APPLICATION TO THE ZONING BOARD OF ADJUSTMENT

Zoning Review Memorandum - Denied

Date: August 21, 2026, *updated October 1, 2026*
Applicant: Bryan Czop
Address: 1 Rosalie Avenue, Rumson, NJ 07760
Block 56, Lot 11, Zone: R-6

In review of the plans for 1 Rosalie Avenue prepared by James T. Daley, Architect, dated April 27, 2026, last revised June 8, 2026, I offer the following:

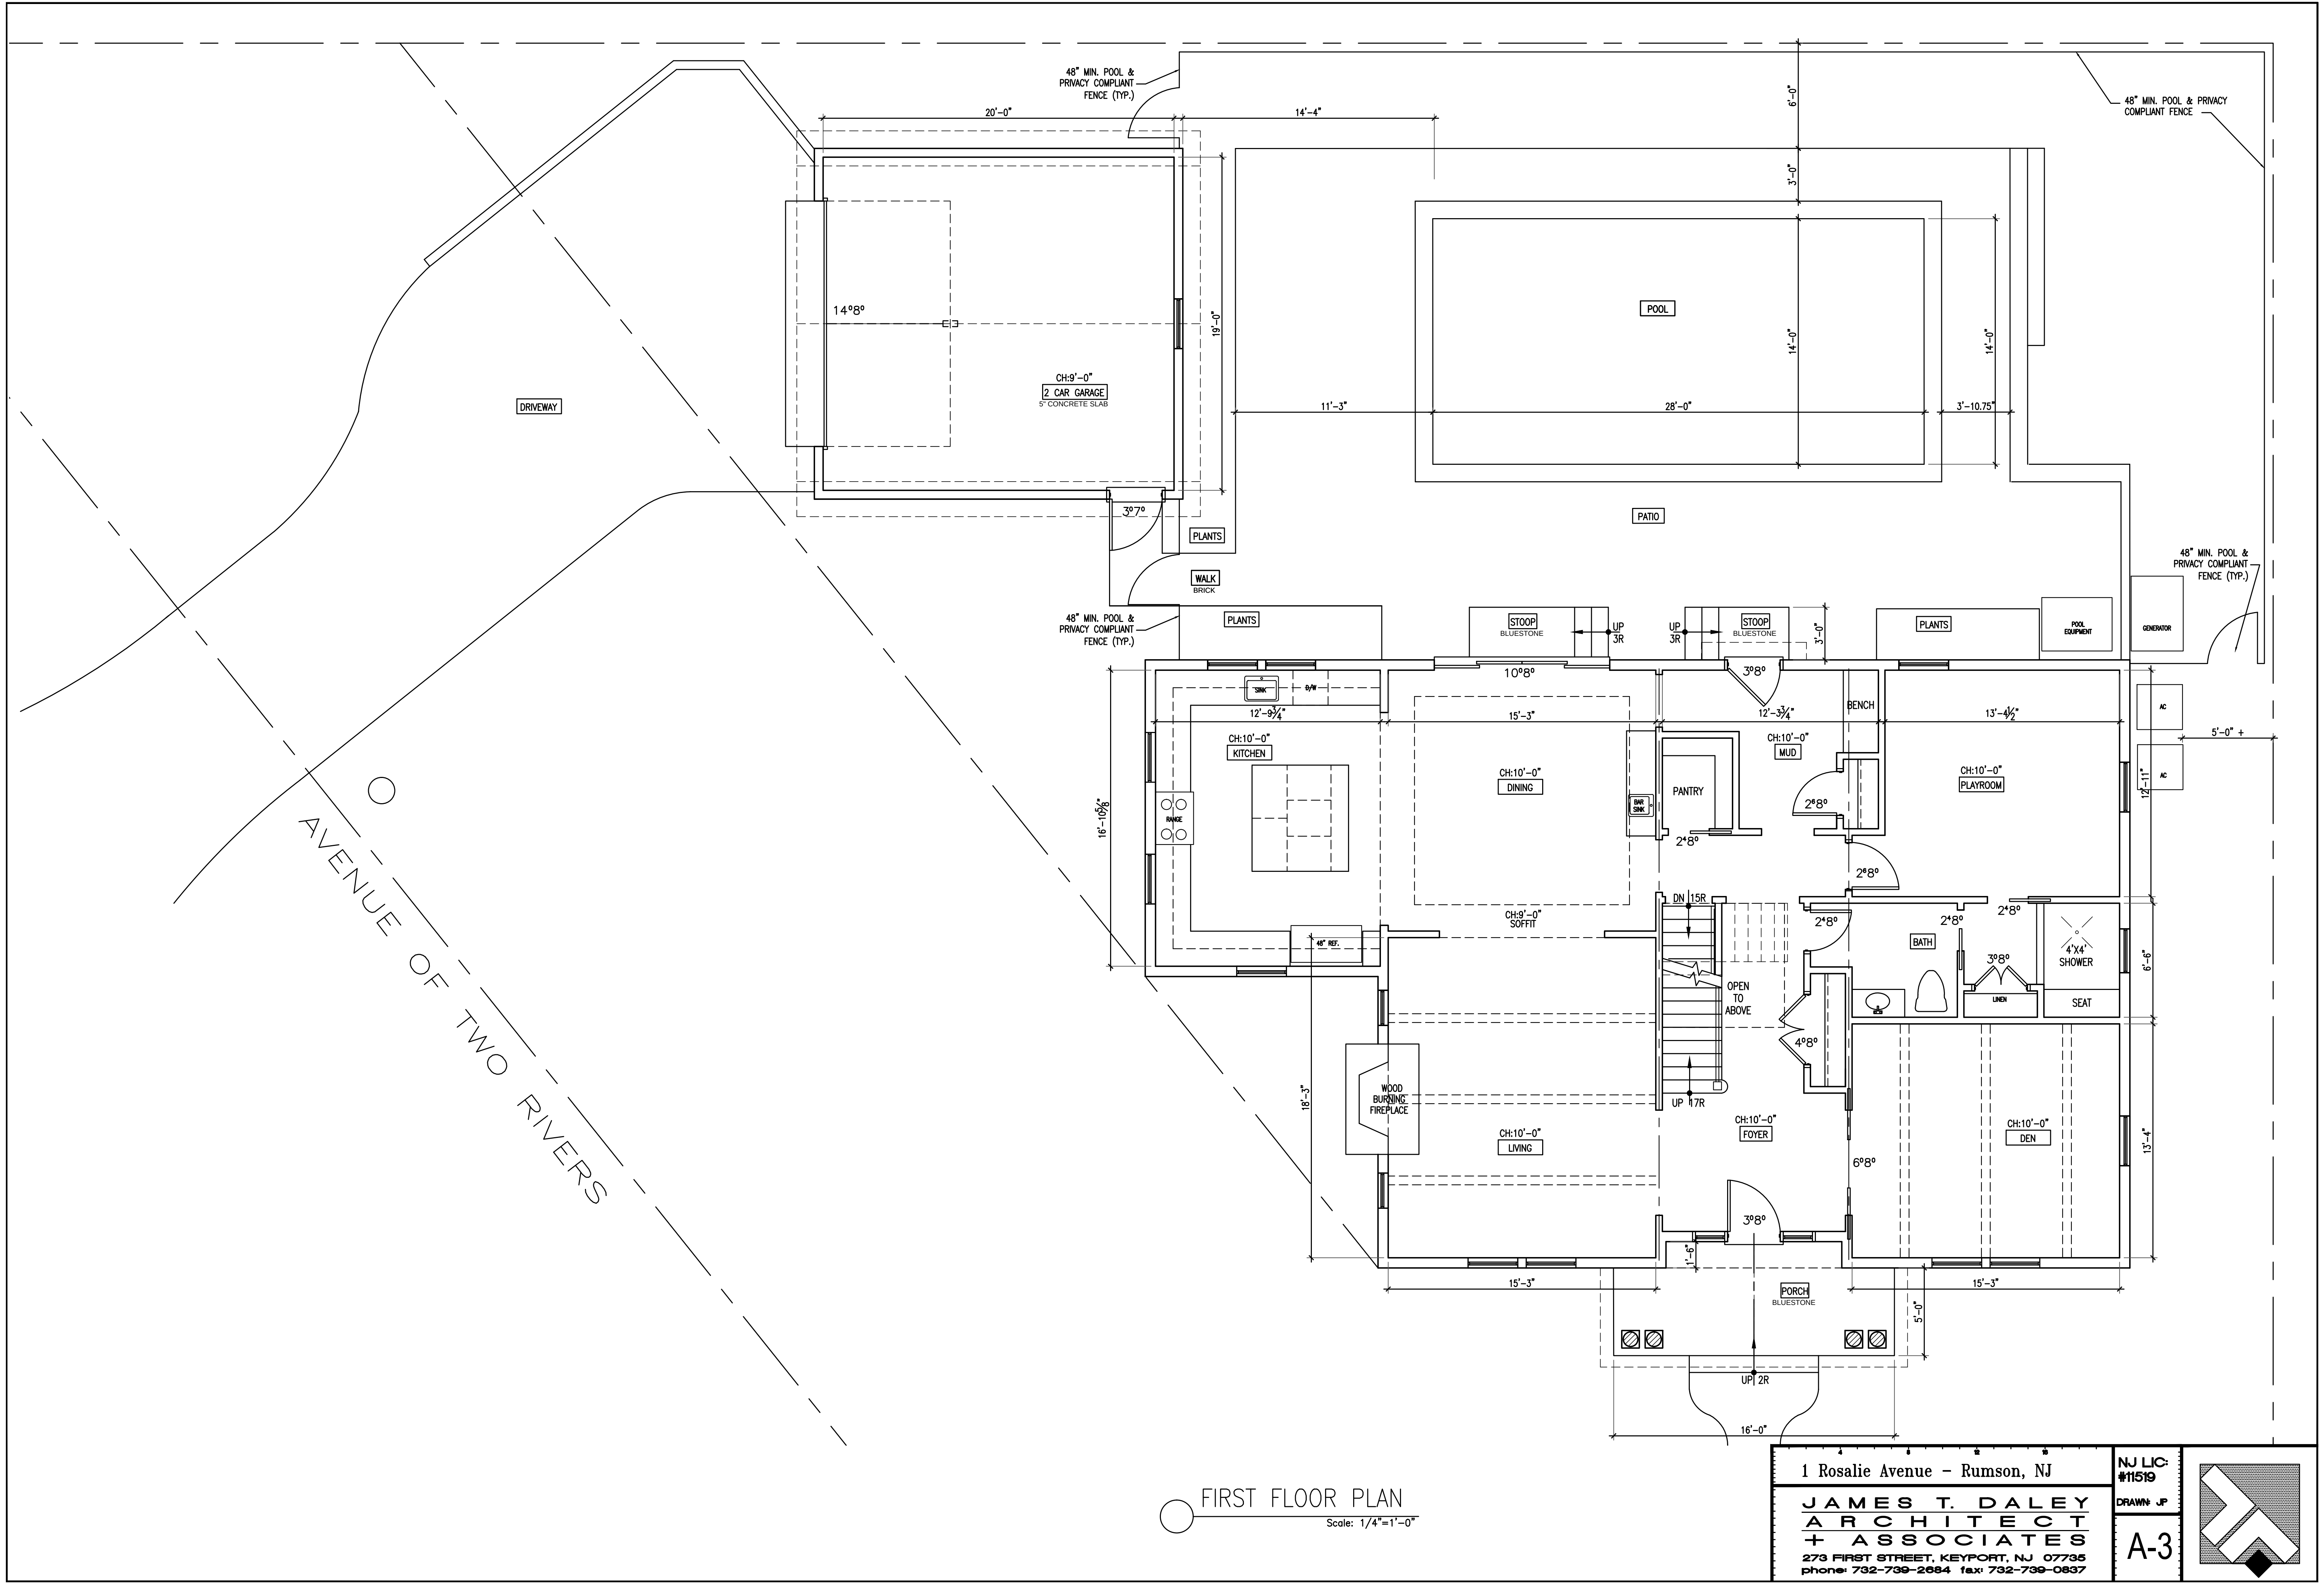
1. The site plan shown on the architectural drawings does not comply with Ordinance Subsection 22-7.27.c, which at a minimum requires existing and proposed lot grading, finished floor elevations, stormwater management provisions, site specific soil and groundwater information and soil erosion and sediment control measures be shown on the plans.
2. As related to stormwater management measures, it appears the project is subject to Ordinance Subsection 16-2, which would require stormwater runoff from 90% of roof areas and 90% of driveway areas be addressed with on-site stormwater management system(s).
3. The proposed driveway configuration does not provide adequate access to the garage in accordance with Ordinance Subsection 22-7.25.j nor does it provide adequate parking behind the front yard setback to accommodate a four bedroom home.

Once a fully developed site plan is prepared, I may be able to offer a more detailed review.

PLOT PLAN

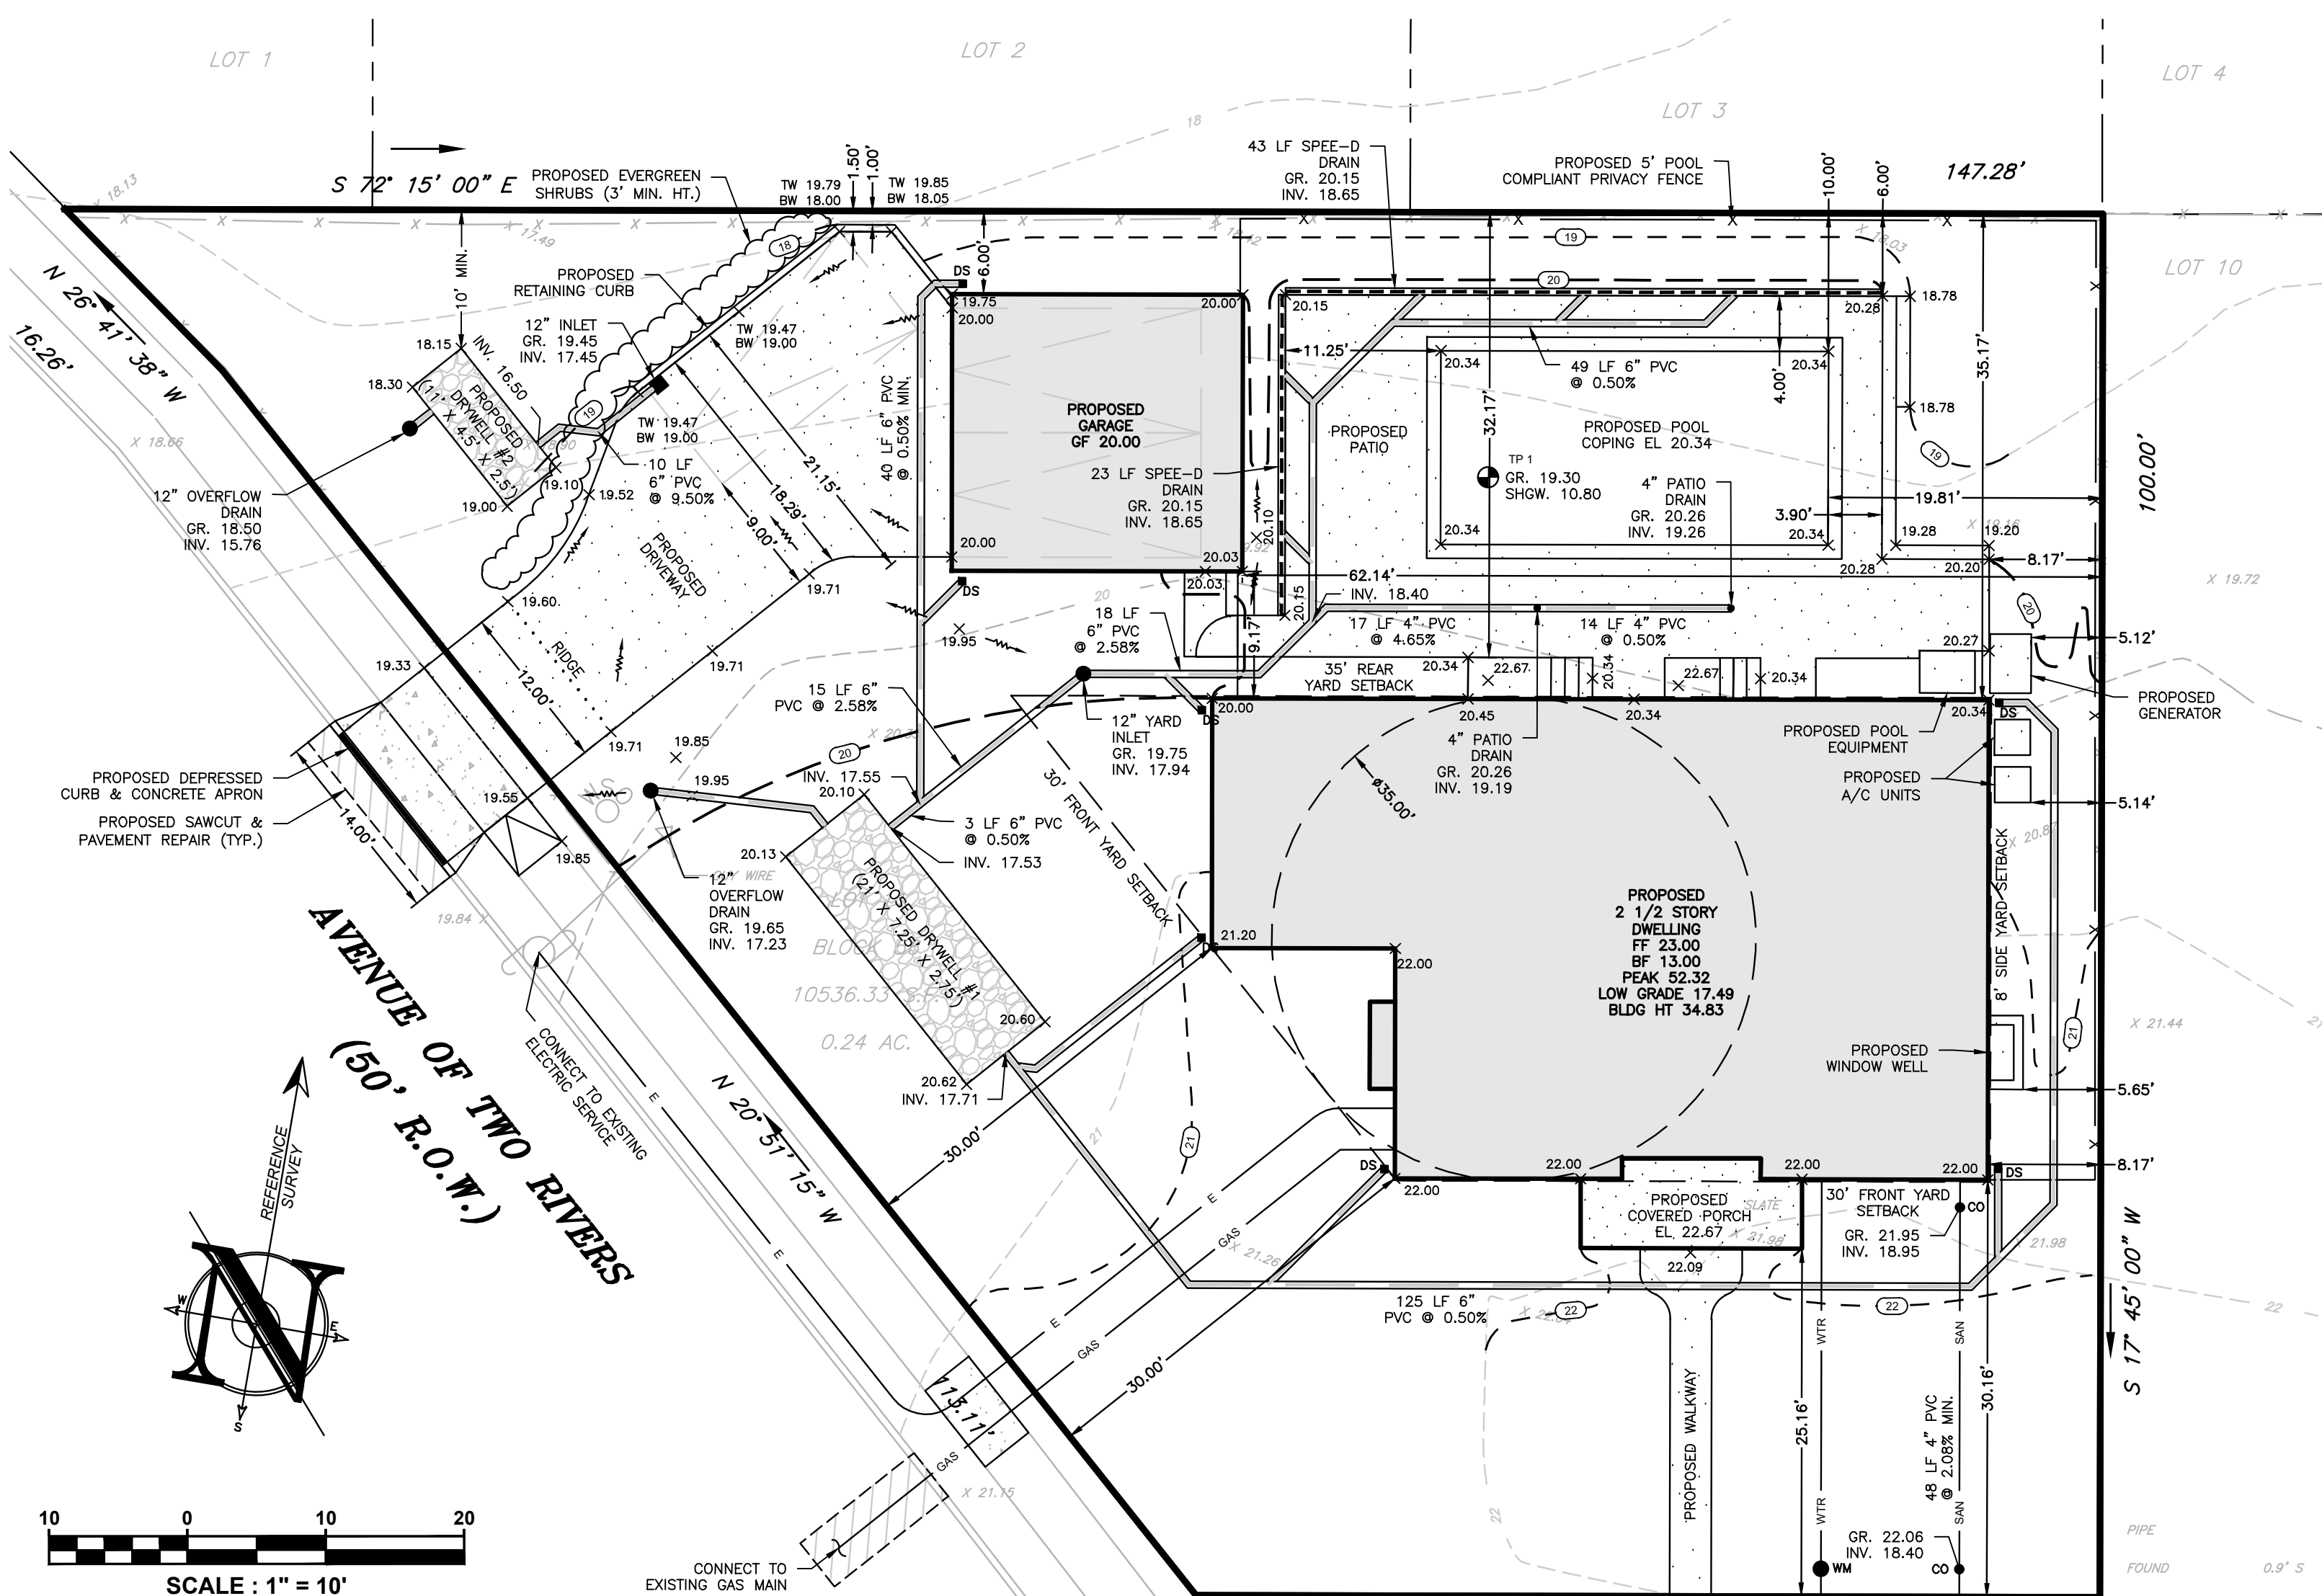
- Basement/Foundation: The Basement/Foundation Plan on Sheet A-2 remains subject to the Borough Engineer's review of the previously requested site-specific soil and groundwater information.
- Driveway Maneuverability: The 9-foot-by-18-foot parking space in the driveway shown on Sheet A-2 creates maneuverability concerns, as discussed via email by the Borough Engineer on June 10, 2026.
